Southeastern Minnesota Center for Independent Living, Inc. Accessibility Assessment Findings and Improvement Options

Property of: **First Unitarian Universalist Church - Rochester**
Address: **1727 Walden Lane Southwest**
Rochester, MN 55902-0901

Conducted On: **September 2, 2015**
SEMCIL Staff: **Robert Weigel, Accessibility Specialist**

Figure 1

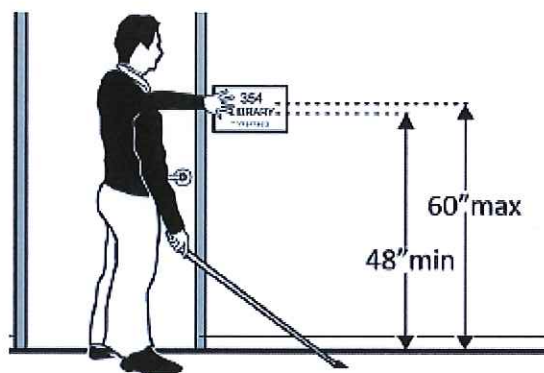
- Provide signage for directing people to the accessible exit using the International Symbol of Accessibility (fig. 1) with raised/brail lettering at a height between 48" and 60" to the lettering (fig. 2).
- Use lever handle door knobs to provide better accessibility
- Grind or replace concrete to provide a smooth traveling surface
- Install ramp side flares or edge protection on the ramp to eliminate the risk of falling off the side of the ramp (fig. 3)

- Provide signage using the International Symbol of Accessibility (fig. 1) to direct people to the accessible parking area.
- Repaint lines at main entrance so that there is at least 3 accessible spaces on level ground. Spaces should be at least 96" wide with a 96" wide access zone (fig. 7). Two spots can share one access zone. At least one spot must be van accessible with the access zone on the passenger side.
- Provide accessible parking signs in front of the parking spots a minimum of 60" above the ground (fig. 8).
- Provide "No Parking" signs designated for the access aisles.

Figure 4

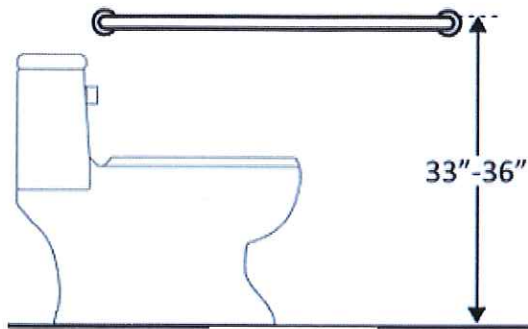
- Provide at least one cut out for sink accessibility with at least 27" of knee clearance (fig. 4). Install insulation around pipes free of sharp/abrasive surfaces to provide protection.
- Adjust grab bars to 33"-36" above the floor (fig. 5).
- Lower sink to ensure the front is at a height no higher than 34" measured to the higher point of the rim or counter top (fig. 6)
- Reverse the door swing so that it does not interfere with the clear floor space within the restroom.
- Provide motion detection light switches.
